Figure 1 – Ungrounded Pad

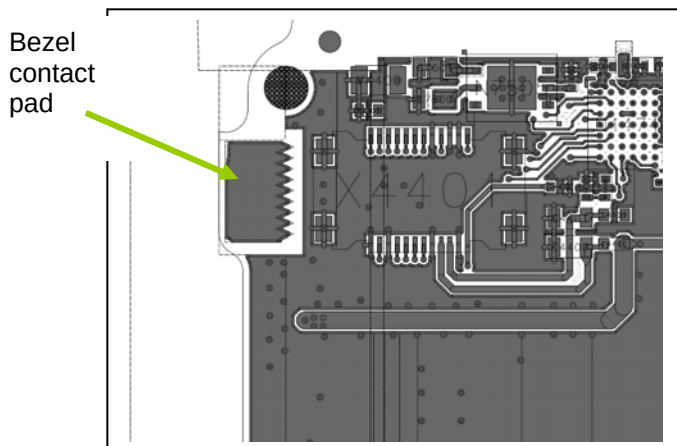
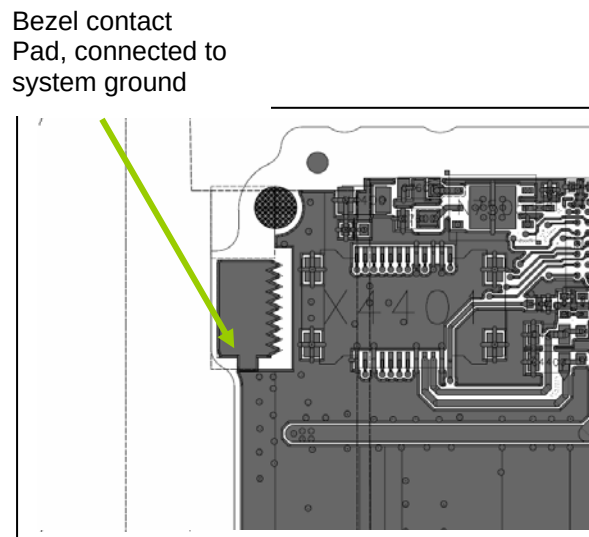
3. Please provide internal photos showing the changes if possible.

Prior to change, the A-cover bezel was not grounded. Satisfactory ESD performance was achieved by connecting the bezel through a spring on the A-cover, to a clip on the UI frame and then to the Bezel contact pad on the main pwb as shown in Figure 1. A spark gap was implemented on the pwb as shown in Figure 1 below

With the new PWB this spark gap has been shorted as shown in Figure 2. This is a copper only change; no component values have been changed.
